# R LEVESQUE ASSOCIATES, INC.

**RE: Response Letter to Peer Review Comments – March 4, 2020  
North Pole Estates – Definitive Subdivision  
RLA Project #190310**

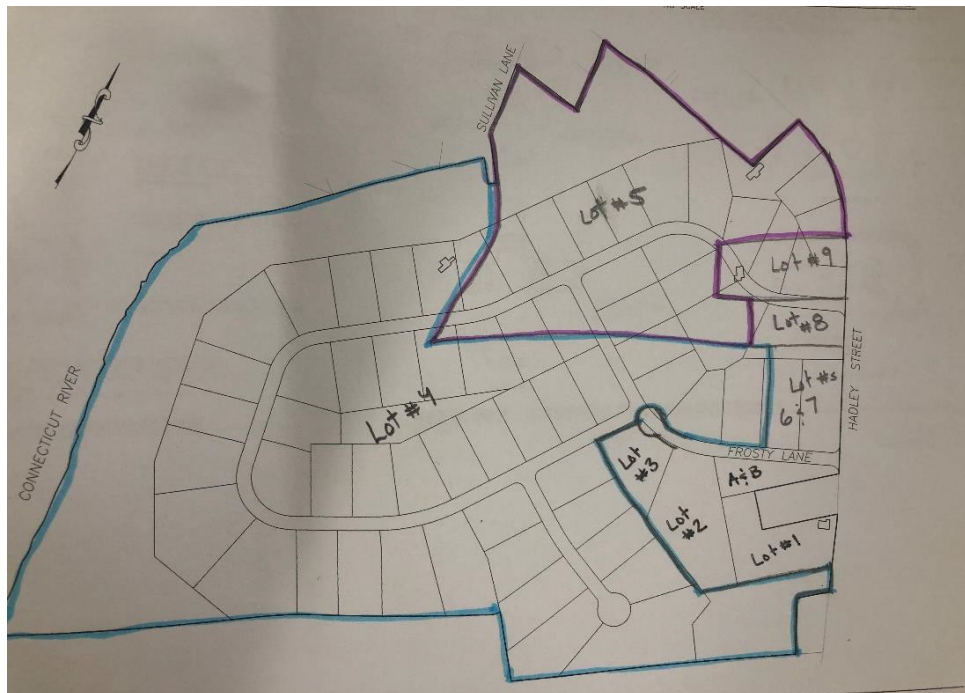
Generally, we find that the Definitive Plans were prepared in accordance with Chapter 360 of the Town's Bylaws; however, we did find inconsistency between the layout dimensions of the Preliminary Plan and the Definitive Plan. The Definitive Plans depict lots 1 through 9, with lots 4 and 5 containing the bulk of the land that would eventually be the remainder of the proposed 67 lots. Many of the lot lines shown for initial lots 1-9 do not coincide with any lot lines for future phases. See the hand-drawn graphic below:

The applicant does not provide a comparison of the lot layout that was proposed for the approved preliminary plan and the lot layout that was proposed for the proposed definitive

plan, but there appear to be discrepancies. The drawing above shows the approximate location of lot lines for lots 4, 5, 8 and 9. Those lines do not appear to coincide with future development lots as depicted. This calls into question the validity of lots 4, 5, 8 and 9 as they do not seem to coincide with lot lines for future development. To address this issue, we recommend that the Town request a phasing plan from the applicant that clarifies why lots

4, 5, 8 and 9 are being created as depicted. We anticipate that future phases will require either redrawing or amendment of the lot lines. This also raises a question related to the ultimate ownership of areas in lots 4 and 5 that are not part of the depicted full-build layout. We recommend that the Town ask for a clarification of this issue.

**RLA Response:** There is no subdivision requirement that the preliminary plan match or resemble the definitive plan and there was no intent to have lot lines from the proposed subdivision coincide with the lots shown on the schematic for “potential” future phases. Any reconfiguration of lots required for future residential use of the land would be handled in the future as necessary through the subdivision process.
